UNITED STATES PATENT AND TRADEMARK OFFICE

APPLICATION NO.	FILING DATE	FIRST NAMED INVENTOR	ATTORNEY DOCKET NO.	CONFIRMATION NO.
09/957,451	09/21/2001	Marc O. Schurr	06530.0276-00000	2507

Office Action Summary

DETAILED ACTION

FIG. 10

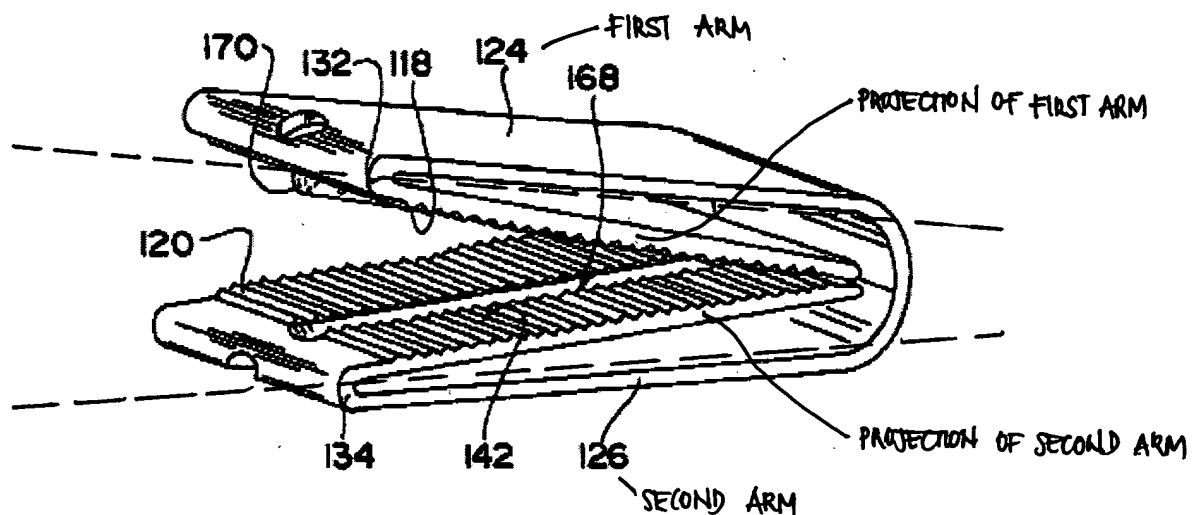
(claims 1, 120, 135 and 148) Figs. 9 and 10 of Yoon discloses a clip that is fully capable of securing a fold of tissue for treating GERD, the clip comprising:

wherein the first and second arms have a first end fixedly connected to each other to define an opening that is capable of receiving a fold of tissue (the clip shown in Fig. 10 is in an open position and can receive tissue),

wherein the first and second arms extend substantially in the same direction as the fold of tissue (see Figs. 9 and 10),

wherein the opening allows tissue to extend beyond a second end of the first and second arm (the clip merely compresses on any object/tissue located between the first and second arms and does not limit any tissue from extending beyond the ends 132 and 134),

wherein the first and second arm includes integral anchoring portions (see attached figure below) which are projections that are capable of maintaining a non-contacting relationship with the other of the first and second arms during a deployed state,

(claims 7, 134, 147 and 157) The first arm and second arm forms a substantially U-shaped configuration, see attached figure above.

(claim 121) The anchoring portion, as illustrated above, is fully capable of engaging a fold of tissue therebetween.

(claims 124, 126, 127, 137, 138, 140 and 149-152) The anchoring portion comprises of two projections, one from each arm and located opposite to one another, and are in the form of a reverse angle barb (see attached figure above).

(claims 130, 143 and 153) The distal end of the first and second arms are tapered (see Figs. 9 and 10).
